January 24, 2018

RE: Comment Response for Front Range-Midway Solar Project, LLC Application for a Wind/Solar Energy Generation Overlay (WSEO), Submittal #1,

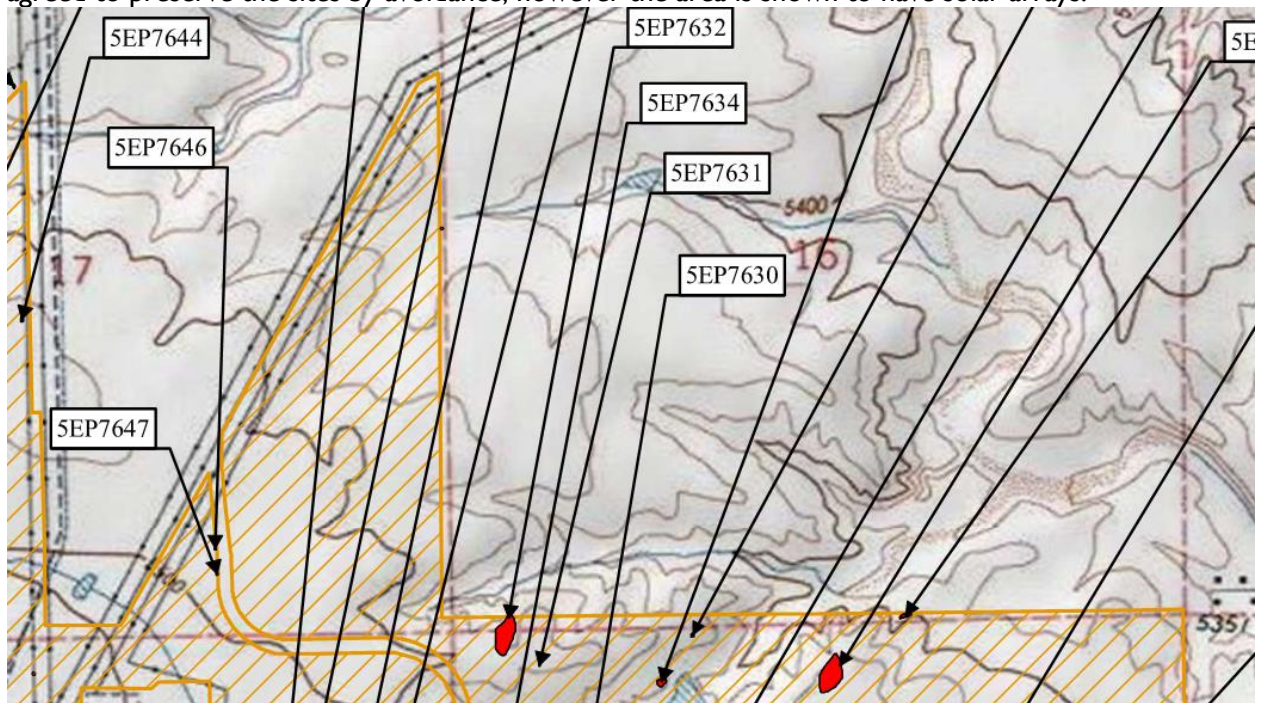
1. Two class III cultural sites (prehistoric) were identified within the project boundary area. [lithic reduction locale, surface assemblage is fragmented- moderate potential for buried cultural materials] The State Historic Preservation Officer (SHPO) and [Front Range-]Midway Solar have agreed to preserve the sites by avoidance; however the area is shown to have solar arrays.

Identified sites to be avoided

Applicant is showing solar arrays on site

2. The sites (5EP7625 and 5EP7632) identified in the September 2016 final environmental assessment are located at the northern portion of the property east of La Questa as depicted above. A letter from the SHPO has been provided. If avoidance cannot be adhered to further excavation would be necessary, please provide further documentation.

Response: Preliminary design has been updated to avoid the potential archeological sites identified in the Class III Cultural Resources Inventory and recommended for avoidance. Please see updated Site Plan (Attachment M), which depicts avoidance of archeological sites. All other Attachments show avoidance of these sites, including the WSEO Plan.
